Model: Cattleya 20bin sorter stapler		Date: 15-Dec-99	No.: MA831001
Modified Article: Parts catalog correction		Prepared by: H. Matsui	
From: Technical Service Dept., GTS Division			
Reason for Modification:	<input checked="" type="checkbox"/> Parts catalog correction	<input type="checkbox"/> Vendor change	<input type="checkbox"/> To meet standards ()
	<input type="checkbox"/> To facilitate assembly	<input type="checkbox"/> To improve reliability	
	<input type="checkbox"/> Part standardization	<input type="checkbox"/> Other

Model: Cattleya 20bin sorter stapler		Date: 31-Jan-00	No.: MA831002
Modified Article: Parts catalog correction		Prepared by: H. Matsui	
From: Technical Service Dept., GTS Division			
Reason for Modification:	<input checked="" type="checkbox"/> Parts catalog correction	<input type="checkbox"/> Vendor change	<input type="checkbox"/> To meet standards ()
	<input type="checkbox"/> To facilitate assembly	<input type="checkbox"/> To improve reliability	
	<input type="checkbox"/> Part standardization	<input type="checkbox"/> Other

Model: Cattleya 20bin sorter stapler	Date: 07-Dec-00	No.: MA831003
--------------------------------------	-----------------	--------------

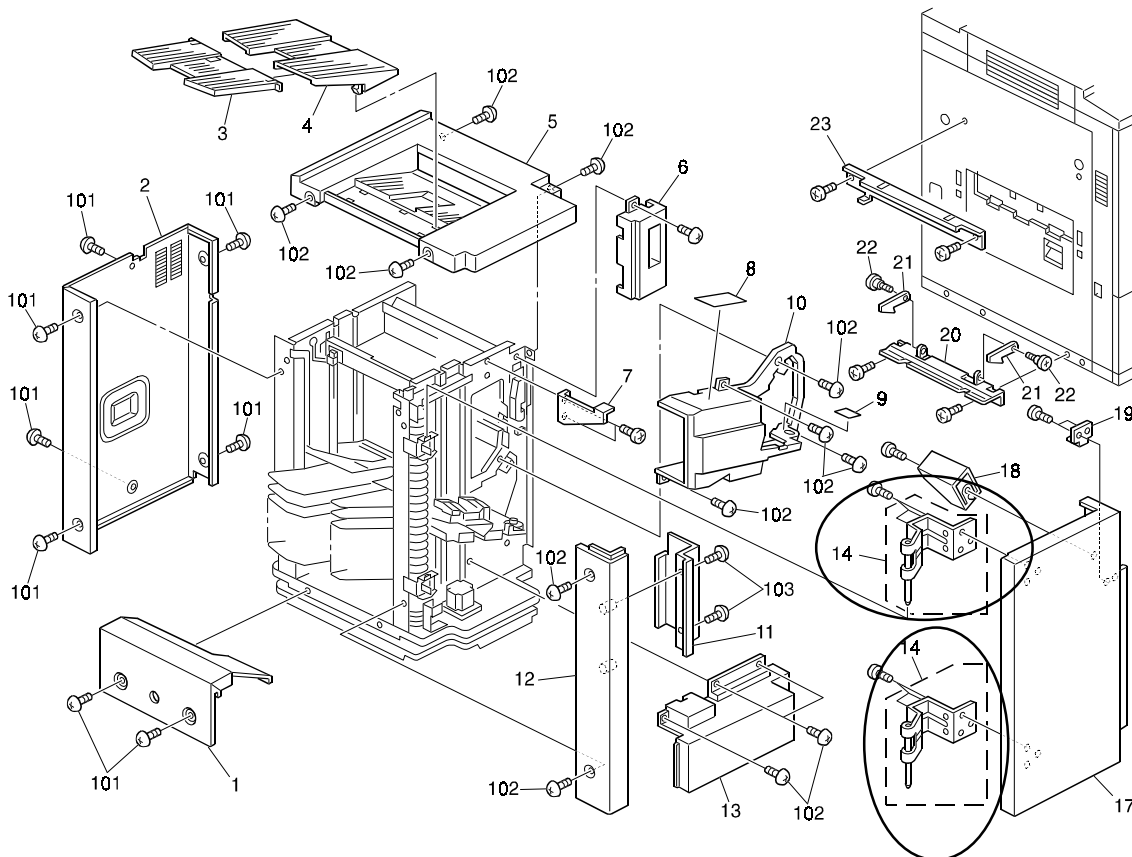
NOTE: Please make following corrections:

1. Index callout # for P/No.A8312562 and A8314511 were incorrect. Index callout # for these two items should be #21 and #22. (Please refer to the previous MB #MA831001 issued on Dec. 15. 1999)
2. P/No. A8311645 (Hinge Bracket : callout #14) is available only as an assembly. Therefore, callouts #15 and #16 should be deleted. Please replace the illustration with the following correct one:

Part number	Description	Page	Incorrect Index	Correct Index
A8312562	Joint Arm	3	15	21
A8314511	Stud Screw – M4	3	16	22

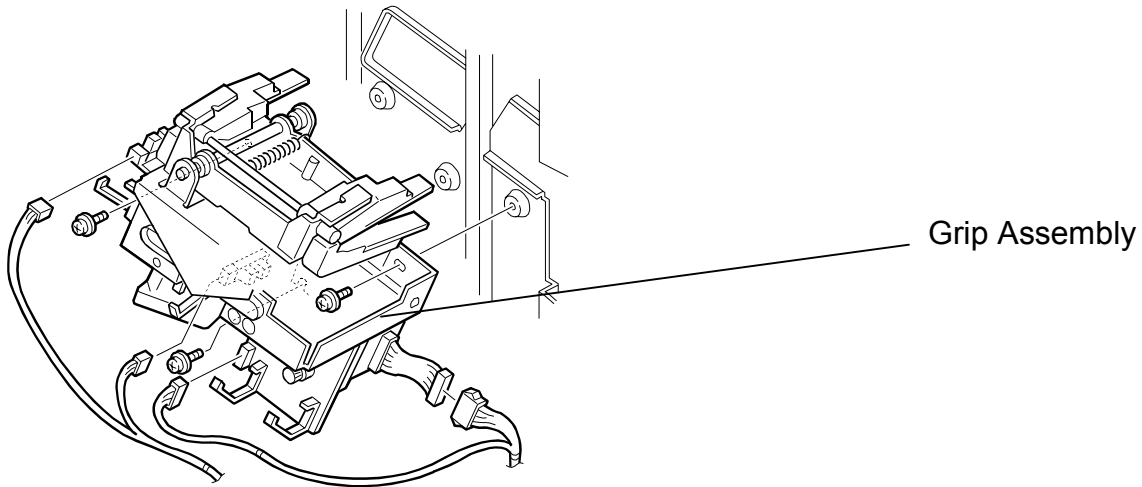
As per field request, the grip assembly has been registered as a spare part.

Old part number	New part number	Description	Q'ty	Int	Page	Index	Note
	A8214400	Grip Assembly	1		5	#*

#: New Index

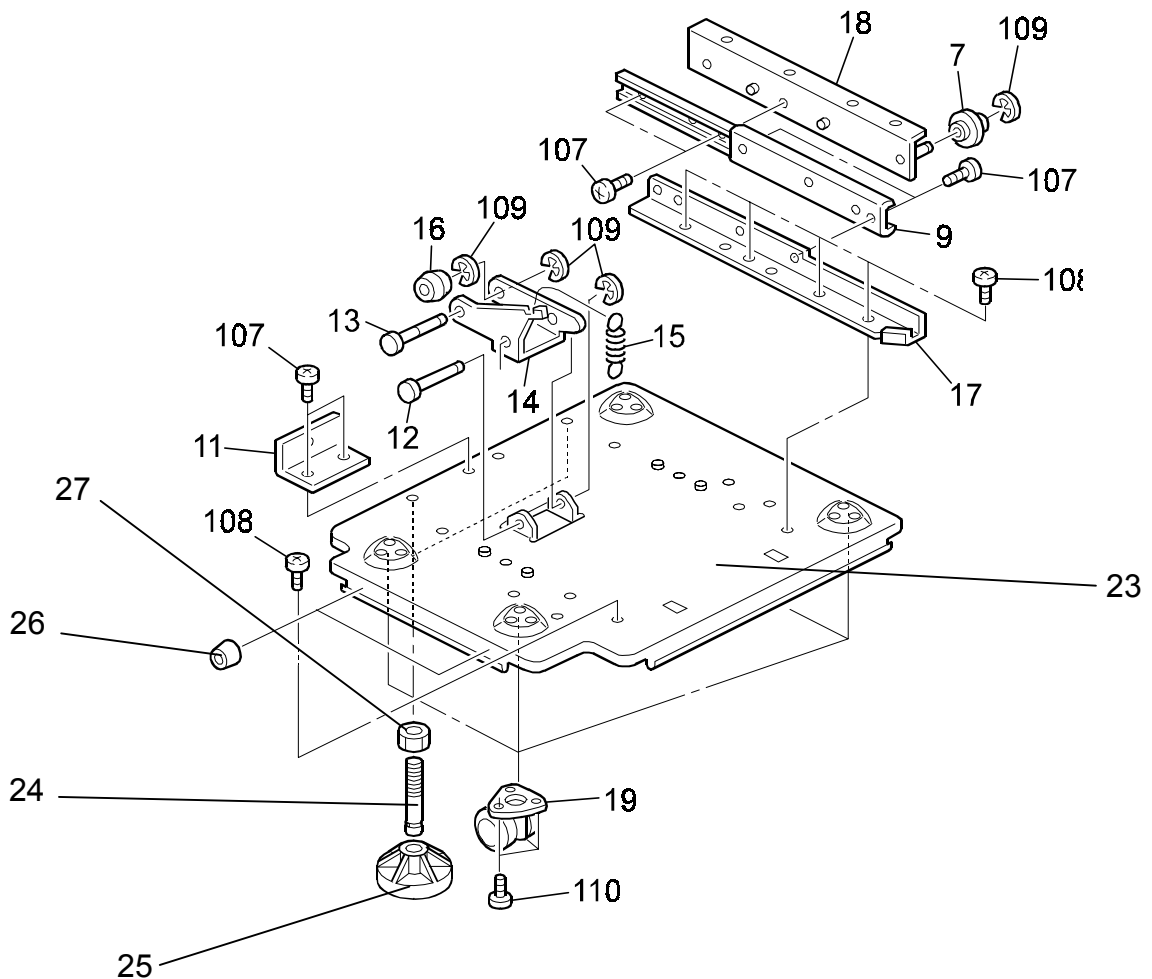
*1: The call out number was missing.

*2: The illustration was missing.

*3: Newly registered item

New part number	Description	Q'ty	Int	Page	Index	Note
A8311552	Base Plate - Lower	1	-	29	23	*1
A8314521	Adjusting Shaft	2	-	29	24	*2
A6816122	Stand Adjuster	2	-	29	25	*2
A8316522	Cushion - 10 x 18	2	-	29	26	*2
08049050	NUT M8	2	-	29	27	*3
